Access Compliance Report Public Rights-of-Way (Curb Ramps)

Intersection ID: 23590 Main Street: KIRCHENBAUM_DR Cross Street: LYTHAM_DR Location: E

ADA ID: 565D5539EA87 Ramp Type: PerpDiag Initial Pass/Fail: Fail Overall Compliance: No Severity Score: 25

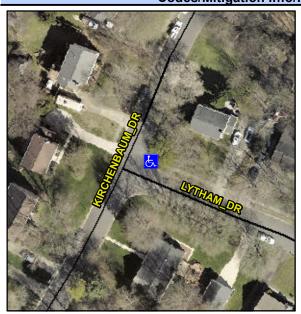
Not Found, R304.5.3

Fleid Measurements/Component Compilance					
Compliance Description		Data	Compliance Description		Data
N/A	Ramp Length (in)	60.0	Yes	Ramp Slope (%)	5.4
Yes	Ramp Width (in)	48.0	No	Ramp XSlope (%)	7.6
N/A	Flare Type LT	N/A	N/A	Flare Type RT	N/A
N/A	Flare Slope LT (%)	N/A	N/A	Flare Slope RT (%)	N/A
N/A	Flare Traversable LT?	N/A	N/A	Flare Traversable RT?	N/A
N/A	Landing Length (in)	N/A	N/A	DWS Provided?	N/A
N/A	Landing Width (in)	N/A	N/A	DWS Contrast?	N/A
N/A	Landing Slope (%)	N/A	N/A	DWS Length (in)	N/A
N/A	Landing X Slope (%)	N/A	N/A	DWS Full Width?	N/A
N/A	Landing Curb? (Y/N)	N/A	N/A	DWS Offset (in)	N/A
N/A	Shared Landing?	N/A			
N/A	Gutter Ponding?	N/A	N/A	Gutter Slope (%)	N/A
N/A	Gutter Lip Ht (in)	N/A	N/A	Gutter X Slope (%)	N/A
N/A	Painted X Walk1?	No	N/A	Painted X Walk2?	No
	X Walk 1 Direction	To NW		X Walk 2 Direction	To SW
N/A	X Walk 1 Width (in)	N/A	N/A	X Walk 2 Width (in)	N/A
	X Walk 1 Slope (%)	0.9		X Walk 2 Slope (%)	6.0

Remove & Replace Curb Ramp With
Two New Directional Ramps or
Equivalent.
